**Co3265 – Pittsford-Brandon NH 019-3(494)**

**ADDENDUM #4**

Plan Sheets 30, 31, 32, 33, 36, 37, 226, 238, 256, 265, 270, 429, 432 & 433 have been revised.

PROJECT NAME: PITTSFORD-BRANDON  
PROJECT NUMBER: NH 019-3(494)  
FILE NAME: z02b198box\_112.dgn  
PROJECT LEADER: P. SHEDD  
DESIGNED BY: R. TRUDEAU  
CULVERT DETAIL SHEET 1 BR 112  
PLOT DATE: 4/10/2026  
DRAWN BY: M. SMITH  
CHECKED BY: J. FRENCH  
SHEET 270 OF 529

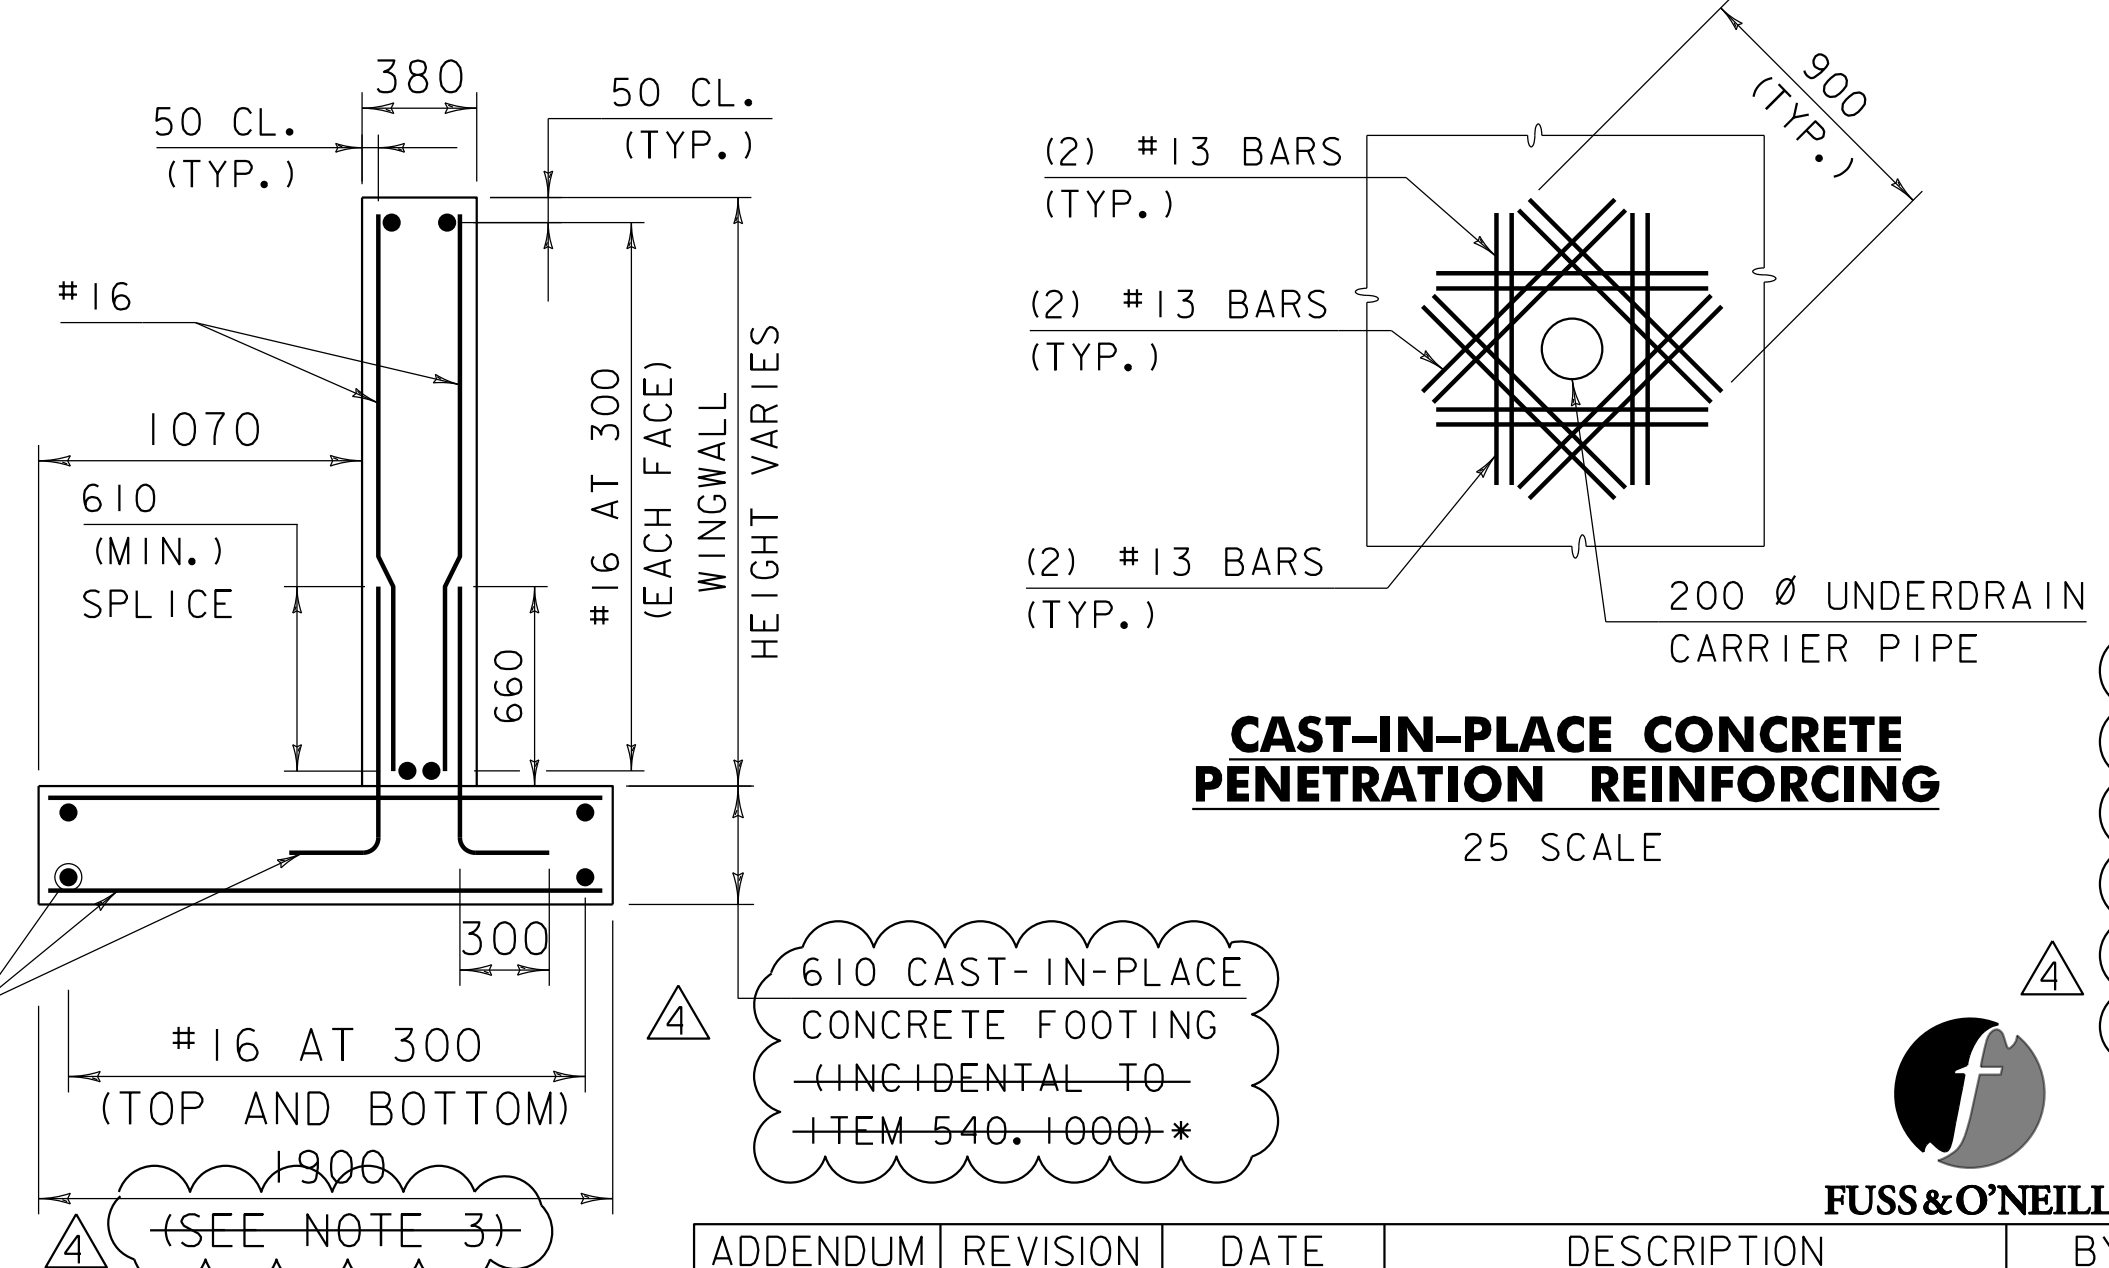
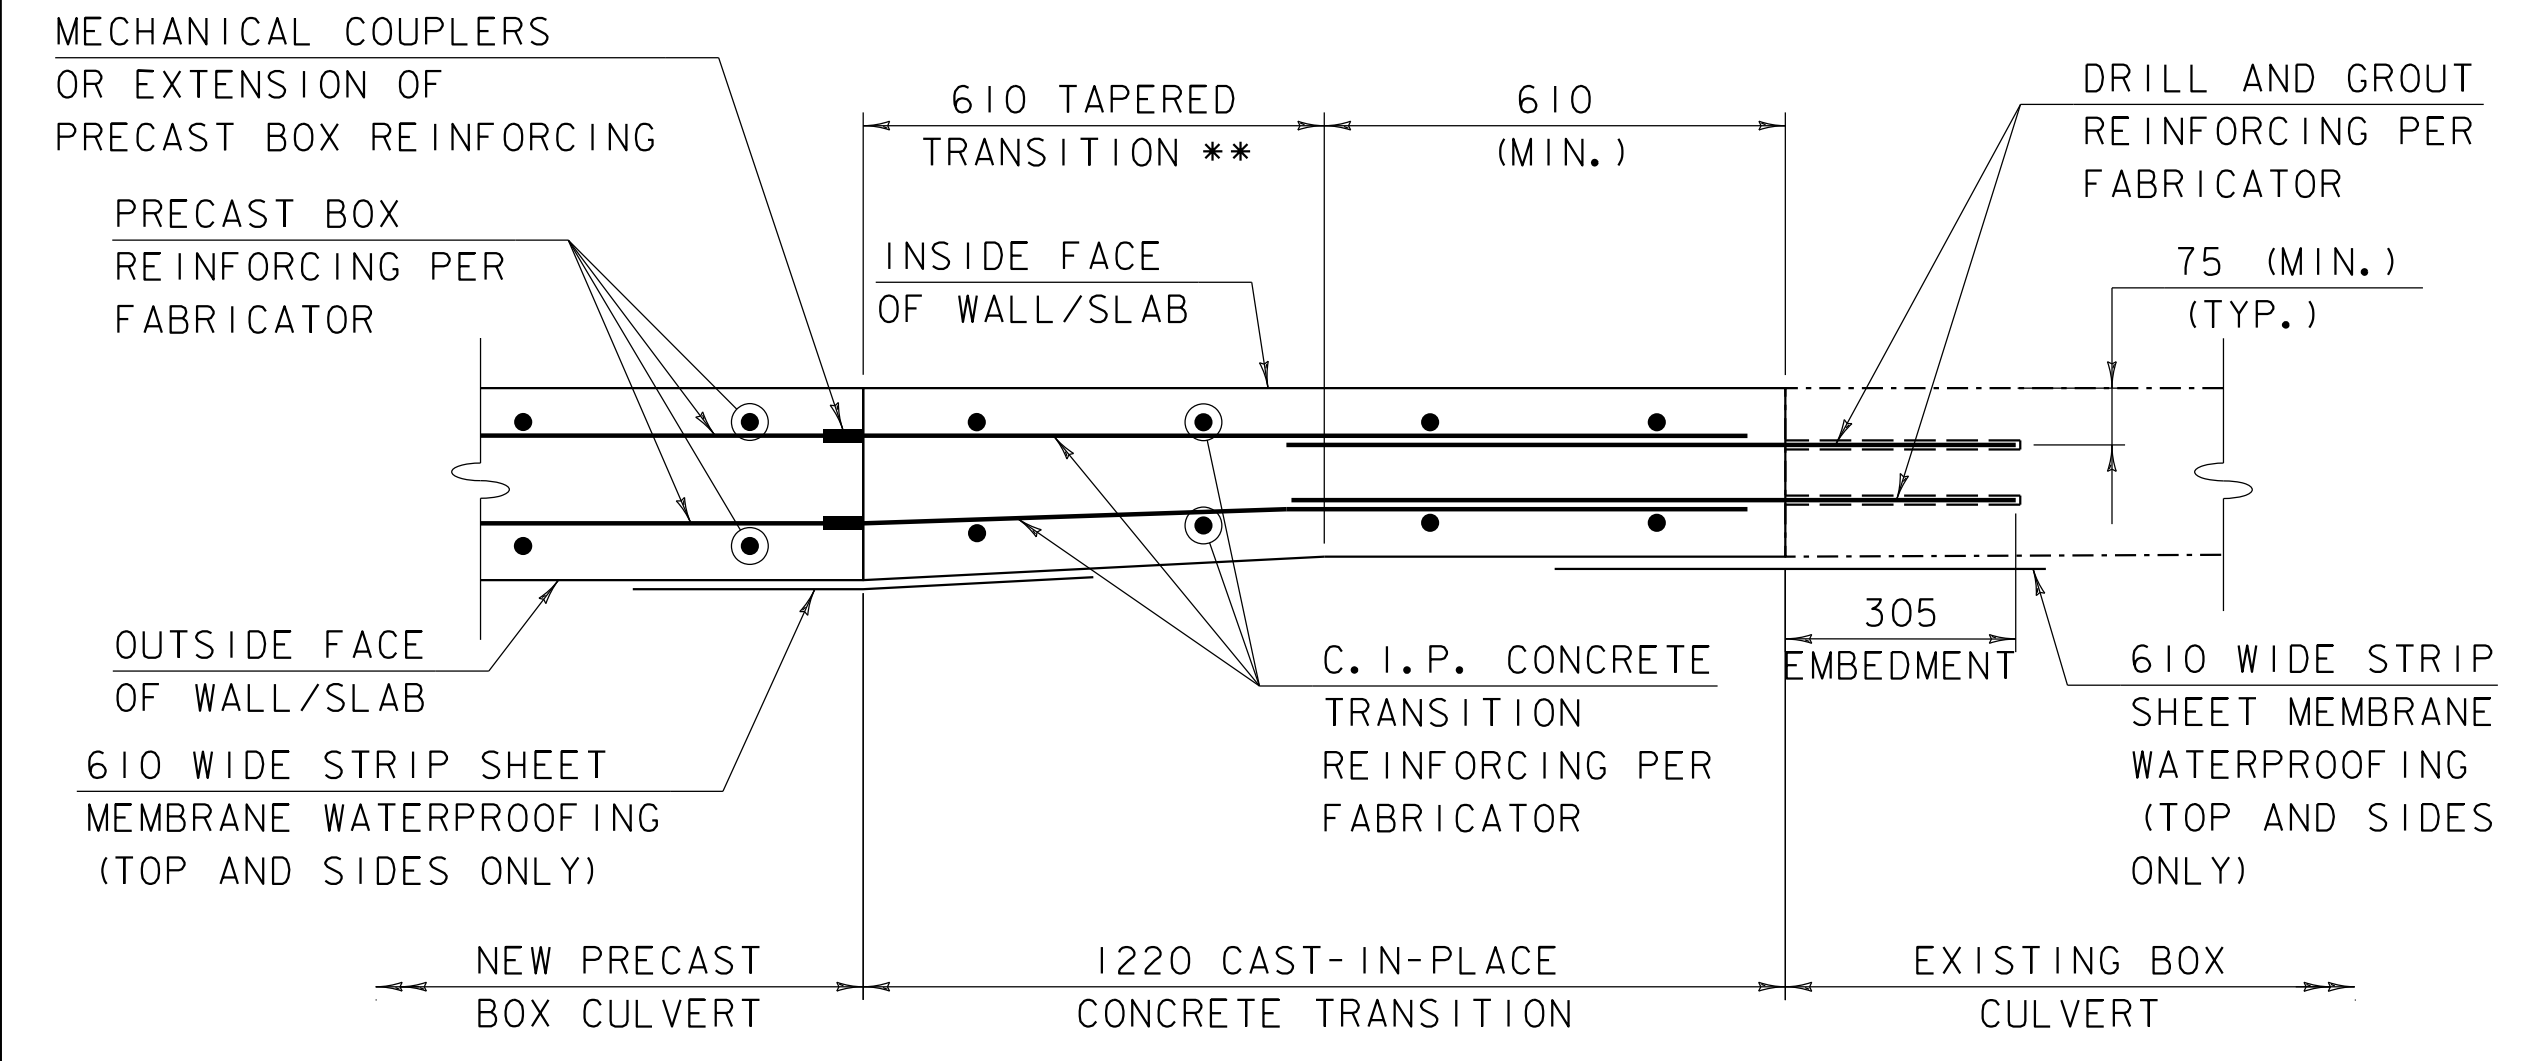
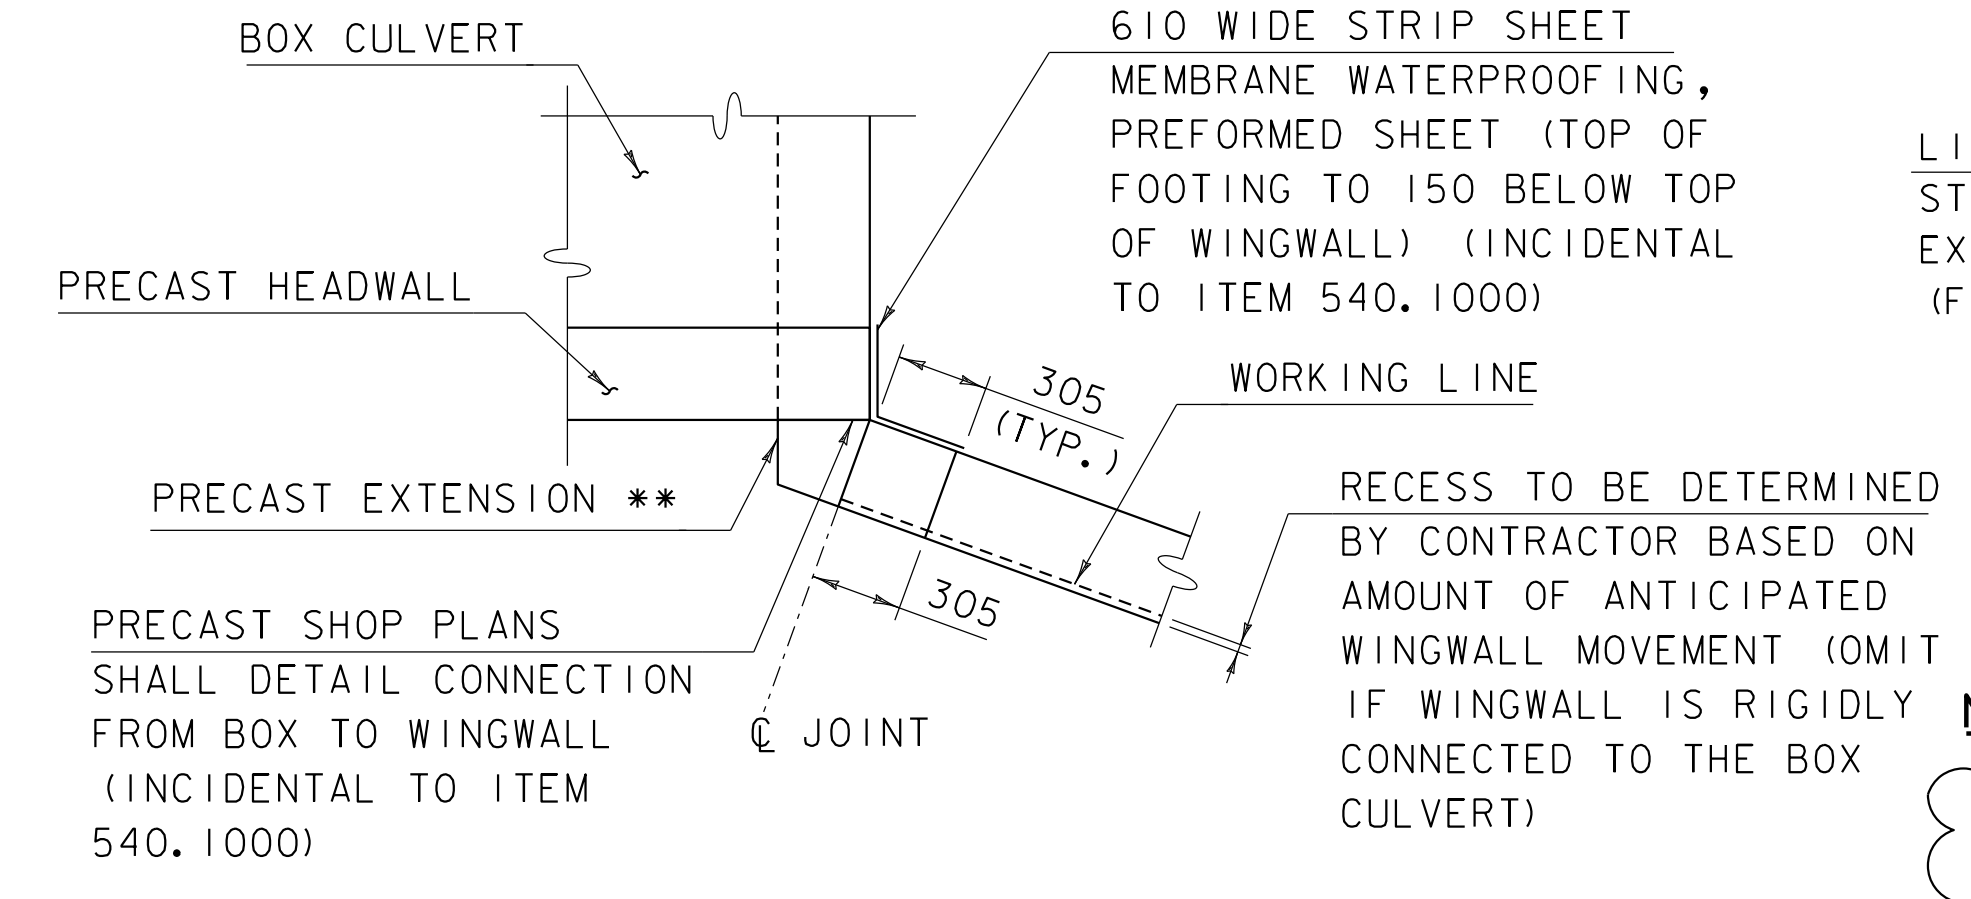
- THE BOTTOM OF EXISTING WINGWALL FOOTING ELEVATION IS UNKNOWN. THE PROPOSED BOTTOM OF WINGWALL FOOTING SHALL MATCH THE EXISTING BOTTOM OF FOOTING, AND THE HEIGHT OF THE PROPOSED WINGWALL SHALL BE ADJUSTED. IF THE ACTUAL HEIGHT OF THE WINGWALL IS GREATER THAN THE HEIGHT SHOWN ON THE PLANS, THE CONTRACTOR SHALL NOTIFY THE ENGINEER TO UPDATE THE WINGWALL DESIGN, DIMENSIONS, AND REINFORCEMENT. NO CONNECTION IS REQUIRED BETWEEN THE EXISTING FOOTING AND PROPOSED FOOTING.

- CONCRETE FOR THE UPSTREAM CAST-IN-PLACE WINGWALL EXTENSIONS SHALL BE PAID FOR UNDER ITEM 541.2200, "CONCRETE, CLASS B". STEEL REINFORCEMENT FOR THE UPSTREAM CAST-IN-PLACE CONCRETE WINGWALL EXTENSIONS SHALL BE PAID FOR UNDER ITEM 507.1100, "REINFORCING STEEL, LEVEL 1 (BLACK)". DRILLING AND GROUTING INTO THE EXISTING CULVERT AT THE UPSTREAM WINGWALL EXTENSION SHALL BE PAID FOR UNDER ITEM 507.1600, "DRILLING AND GROUTING DOWELS".

ADDENDUM	REVISION	DATE	DESCRIPTION	BY
4	1	4-10-26	BR#112 UPSTREAM WINGWALL EXTENSION REVISIONS	SRB

PROJECT NAME:	PITTSFORD - BRANDON		
PROJECT NUMBER:	NH 019-3 (494)		
PROJECT LEADER:	G. GOYETTE	DRAWN BY:	D. BARNES
DESIGNED BY:	D. YOULEN	CHECKED BY:	I. MAYNARD
FILE NAME:	d02b198_typ.dgn	PLOT DATE:	4/10/2026
TTC PHASING TYPICAL SECTION SHEET 2		SHEET	432 OF 529

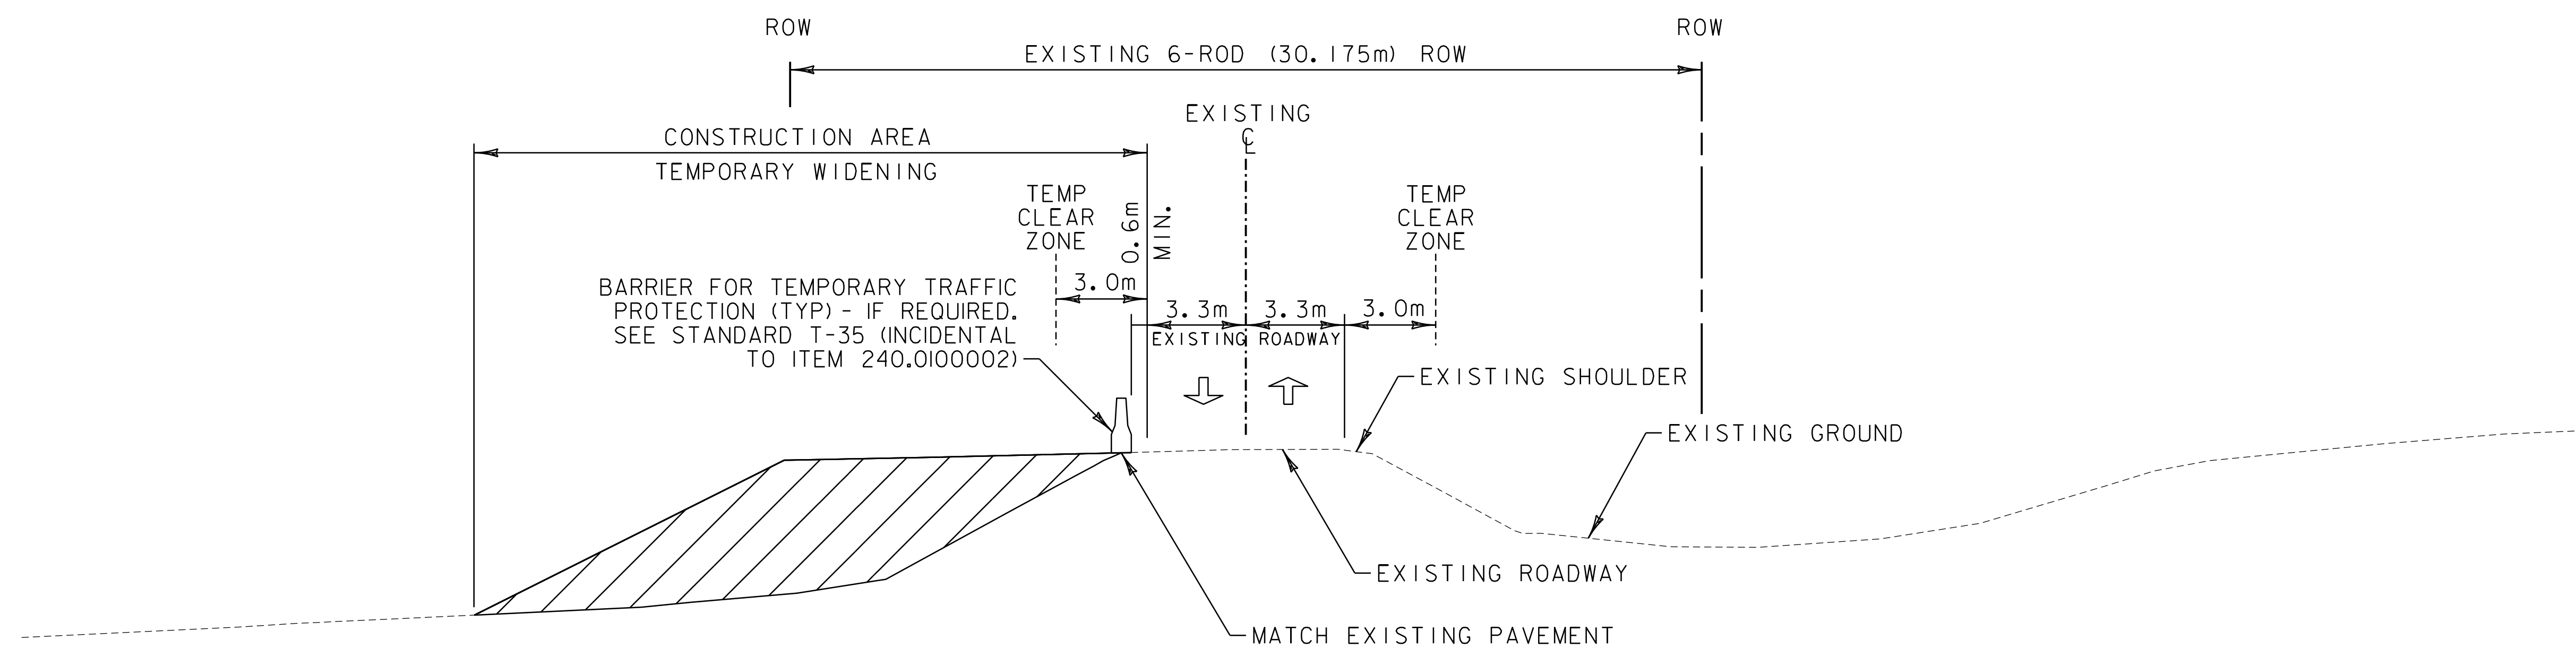
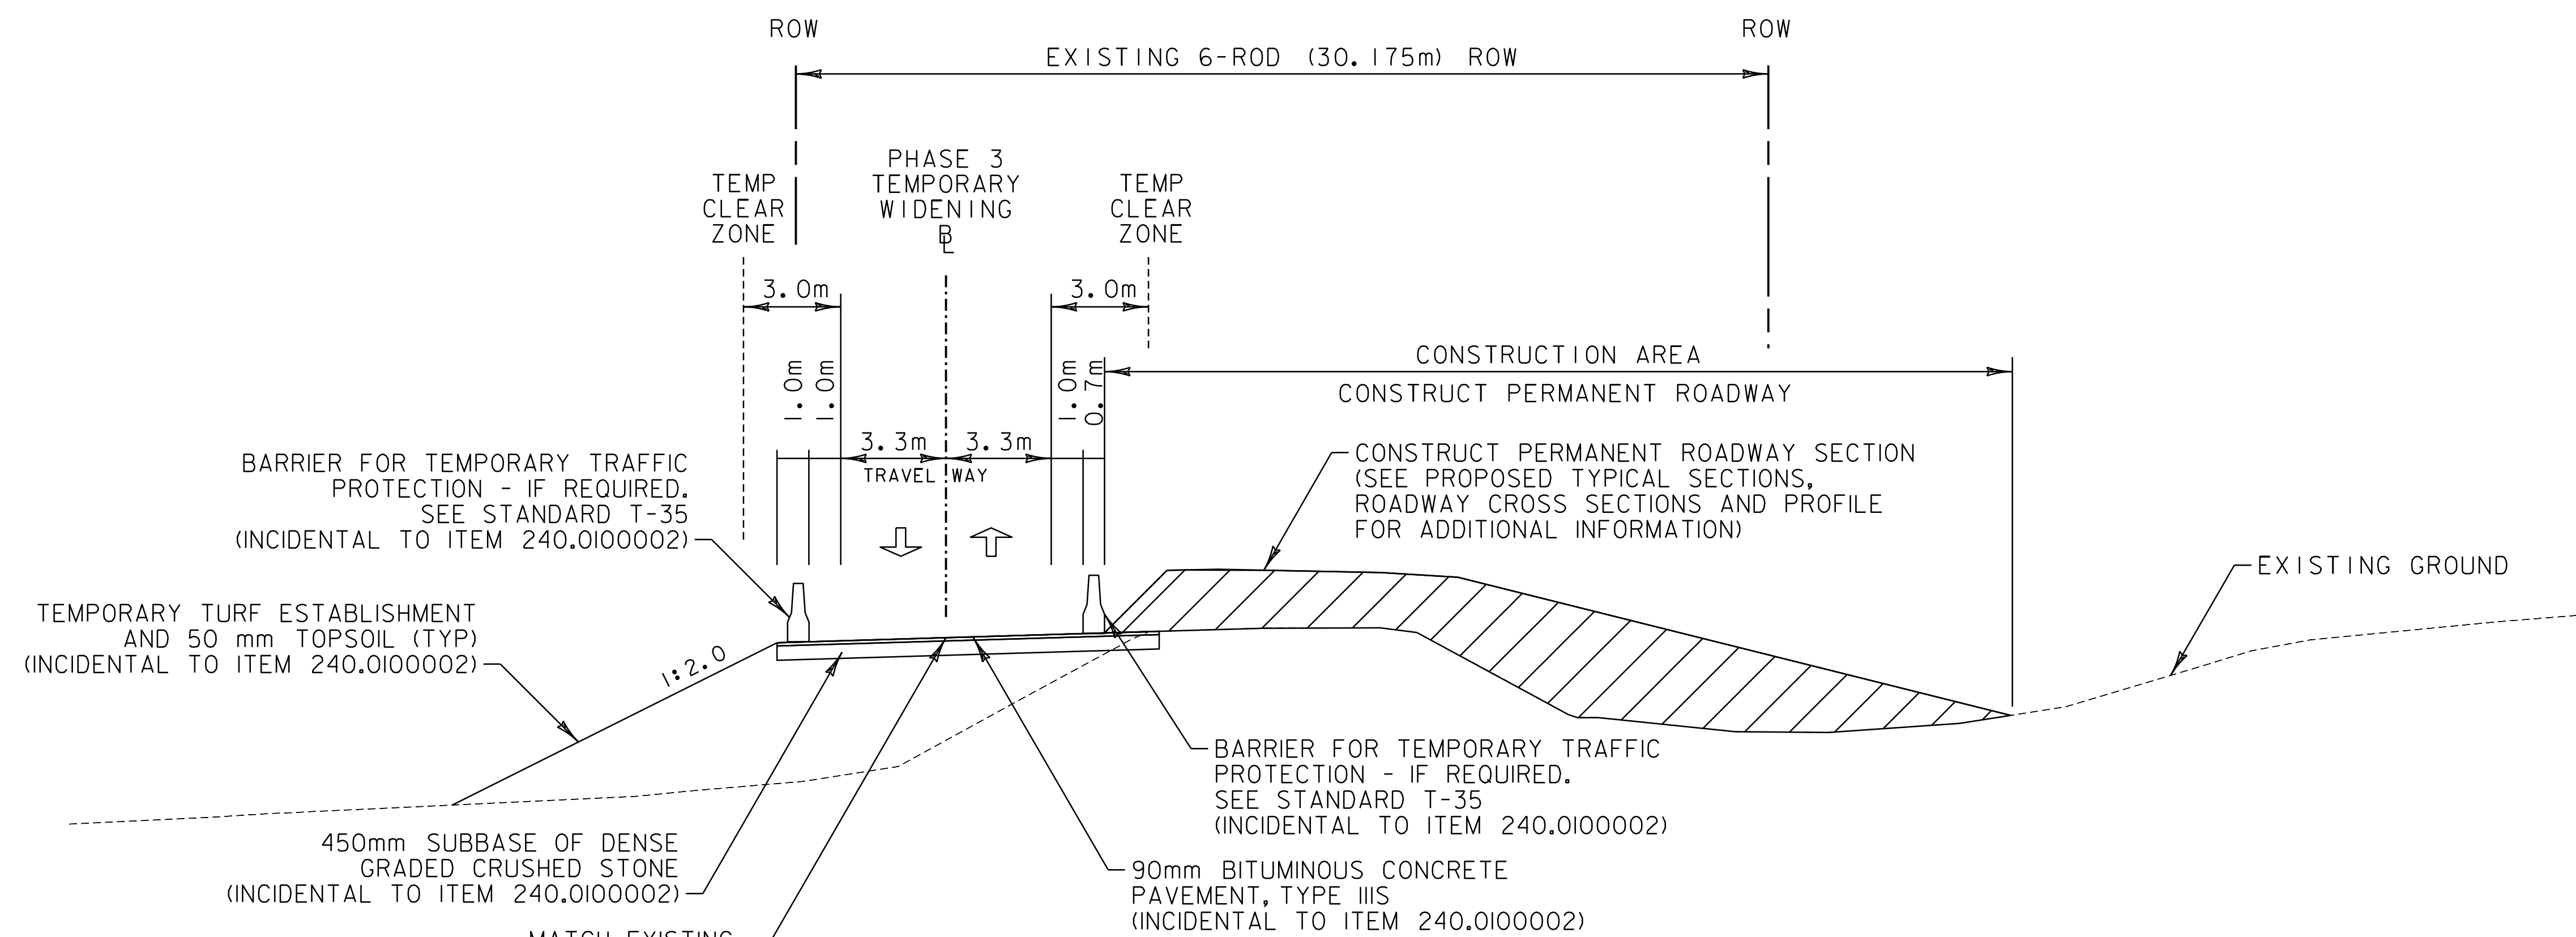
NOTE: THE CONTRACTOR MAY PROPOSE TO USE OTHER MATERIALS IN PLACE OF THE DENSE GRADED CRUSHED STONE IN THE TEMPORARY WIDENING AND/OR DIVERSION. THE CONTRACTOR SHALL SUBMIT ANY SUBSTITUTIONS AS PART OF THE TEMPORARY ROADWAY SUBMITTALS AND BE APPROVED BY THE ENGINEER. ANY SUBSTITUTED MATERIAL WILL BE CONSIDERED INCIDENTAL TO ITEM 240.0100002 OR ITEM 240.0100003.

ADDENDUM	REVISION	PLOT DATE	DESCRIPTION	BY
A	1	04-10-2026	NOTE ADDED	DMY
